9605170429 960509
PDR ADOCK 05000416
P PDR

SR 3.4.4.3.a BASES

Dikkers Type Dual-Function Safety/Relief Valve

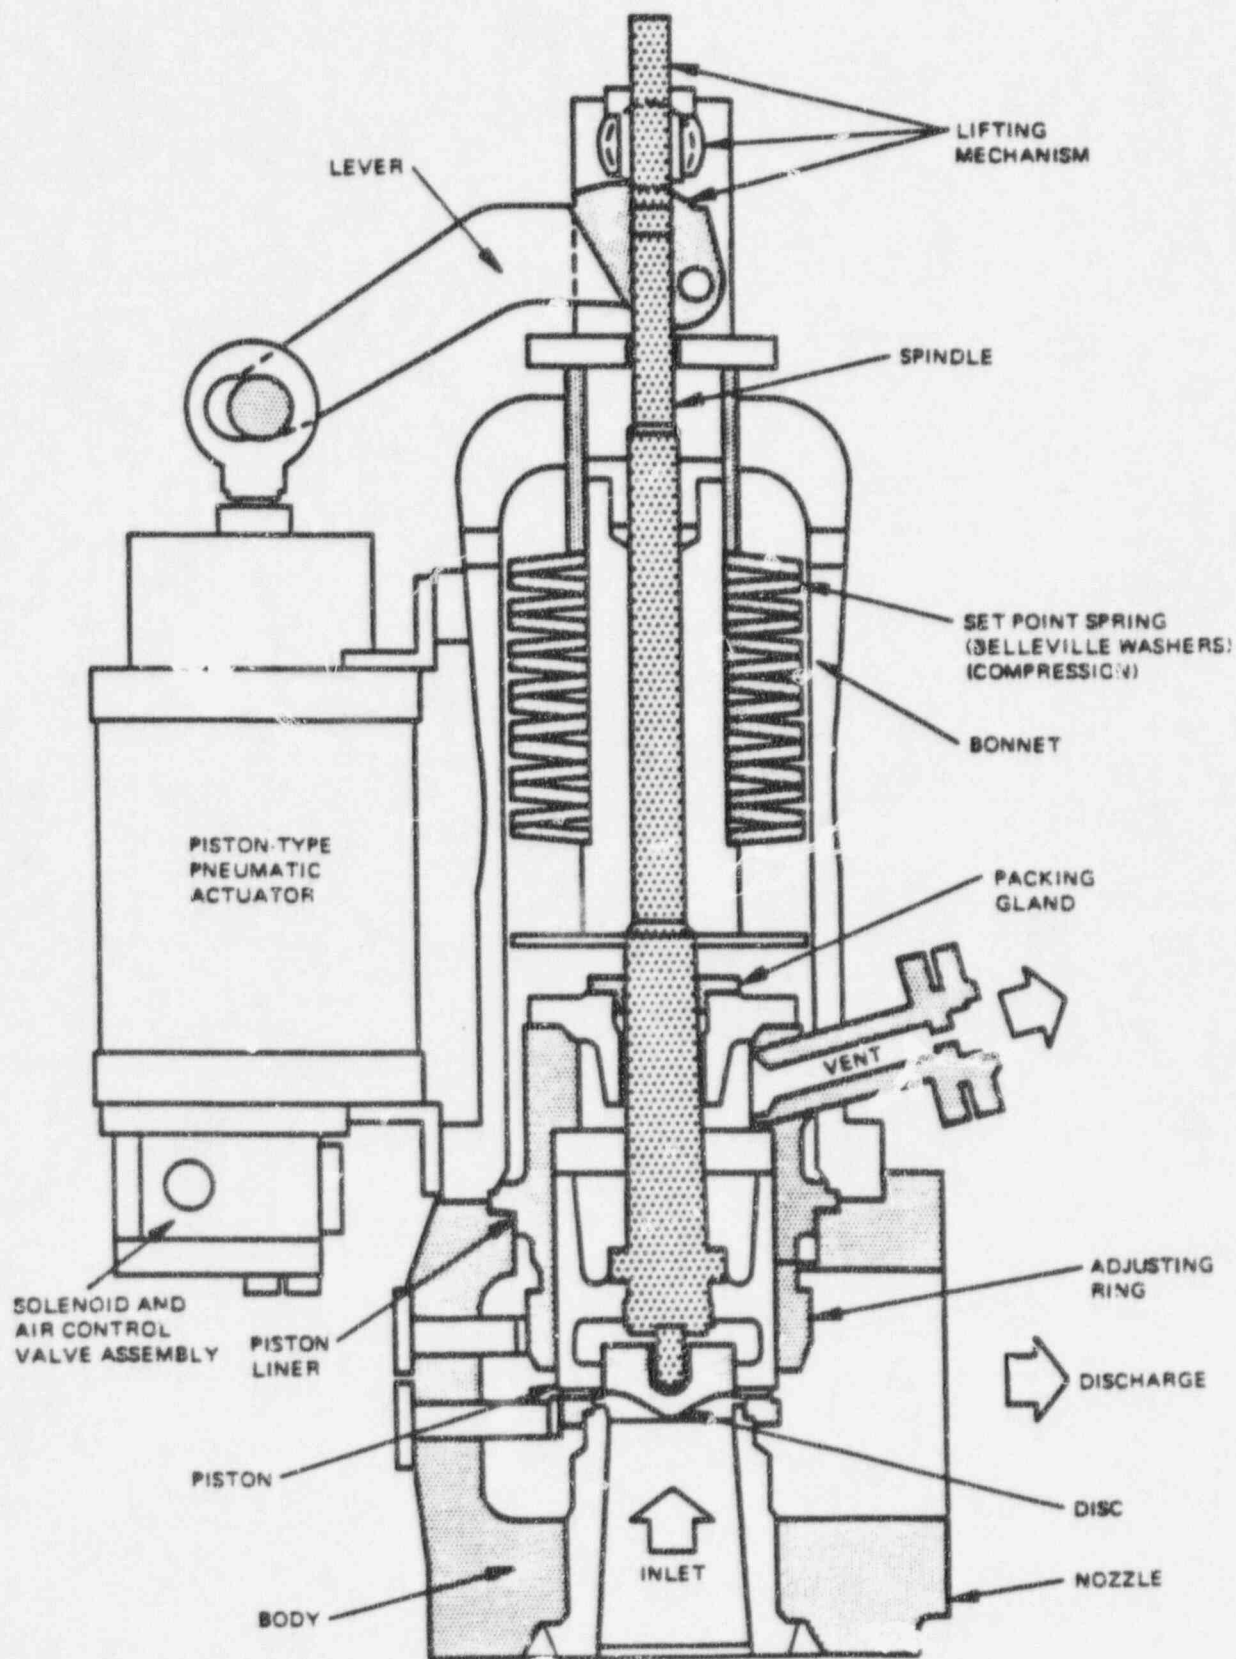
A manual actuation of each required LLS valve (those valves removed and replaced to satisfy SR 3.4.4.1.) is performed to verify that the valve is functioning properly. This SR can be demonstrated by one of two methods. If performed by method 1), plant startup is allowed prior to performing this test because valve OPERABILITY and the setpoints for overpressure protection are verified, per ASME requirements, prior to valve installation. Therefore, this SR is modified by a Note that states the Surveillance is not required to be performed until 12 hours after reactor steam pressure and flow are adequate to perform the test. The 12 hours allowed for manual actuation after the required pressure is reached is sufficient to achieve stable conditions for testing and provides a reasonable time to complete the SR. If performed by method 2), valve OPERABILITY has been demonstrated for all installed LLS valves based upon the successful operation of a test sample of S/RVs.

1) Manual actuation of the LLS valve, with verification of the response of the turbine control valves or bypass valves, by a change in the measured steam flow, or any other method suitable to verify steam flow (e.g., tailpipe temperature or pressure). Adequate reactor steam pressure must be available to perform this test to avoid damaging the valve. Also, adequate steam flow must be passing through the main turbine or turbine bypass valves to continue to control reactor pressure when the LLS valves divert steam flow upon opening. Sufficient time is therefore allowed after the required pressure and flow are achieved to perform this test. Adequate pressure at which this test is to be performed is consistent with the pressure recommended by the valve manufacturer.

2) The sample population of S/RVs tested each refueling outage to satisfy SR 3.4.4.1 will be stroked in the relief mode during "as-found" testing to verify proper operation of the S/RV. The successful performance of the test sample of S/RVs provides reasonable assurance that all LLS valves will perform in a similar fashion. After the S/RVs are replaced, the relief-mode actuator of the newly-installed S/RVs will be uncoupled from the S/RV stem, and cycled to ensure that no damage has occurred to the S/RV during transportation and installation. This verifies that each replaced S/RV will properly perform its intended function.
